ADDENDUM NUMBER ONE

RFQ # 7465370

**TITLE: Electrical Emergency Repairs, Port of Galilee, Narragansett, RI -
DEM**

State of Rhode Island
Bid Number 7465370
Electrical Emergency Repair
Port of Galilee
Narragansett, Rhode Island

2
E2
CABLE SUPPORT DETAIL FOR PIERS (TYPICAL)

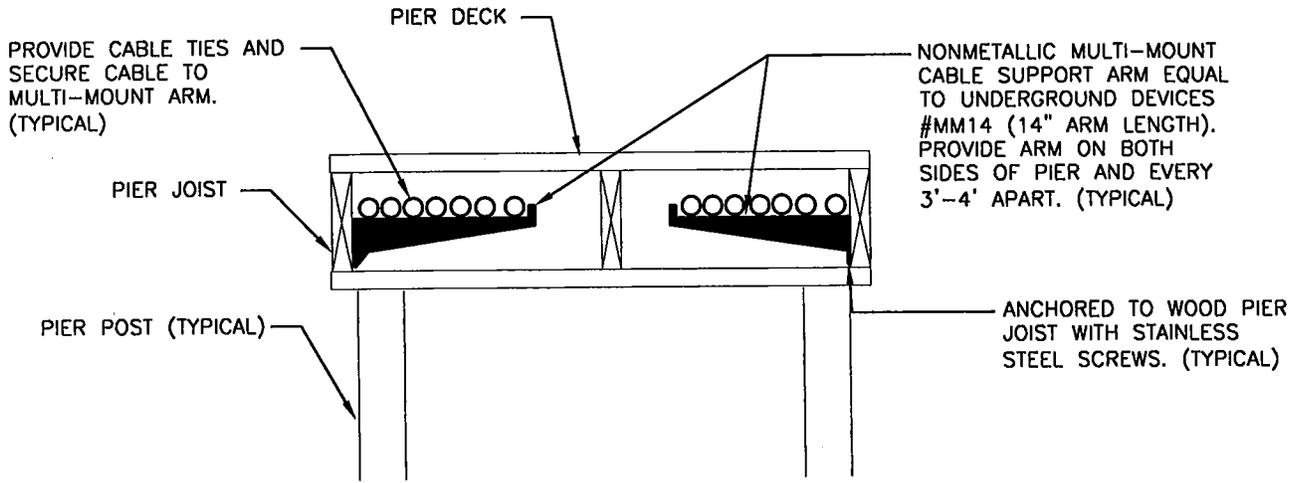
- ITEM A)** Drawing 2 – Provide work shown on Sketch SKE-1.
Add the following notes:
1. Cables shall be properly supported.
 2. Cables shall be located on the underside of the Pier.
 3. Cables shall be securely fastened to structural members other than the deck planking.
 4. Cables shall not be installed where subject to physical damage.
 5. Where cables pass through structural members, they shall be protected against chafing by a permanently installed oversized sleeve of non-metallic material.
- ITEM B)** Drawing 3 – Mahole in front of Pier SS is existing to remain. Delete Note “New manhole (typ.) refer to detail 5/E1”
- ITEM C)** Drawing 4 – Delete existing telephone cable, devices, boxes, etc. on Pier RR and Pier SS.
- ITEM D)** Sign-in sheet from mandatory prebid conference is attached.

1. COORDINATE EXACT LOCATION OF MULTI-MOUNT CABLE SUPPORT ARM IN FIELD.
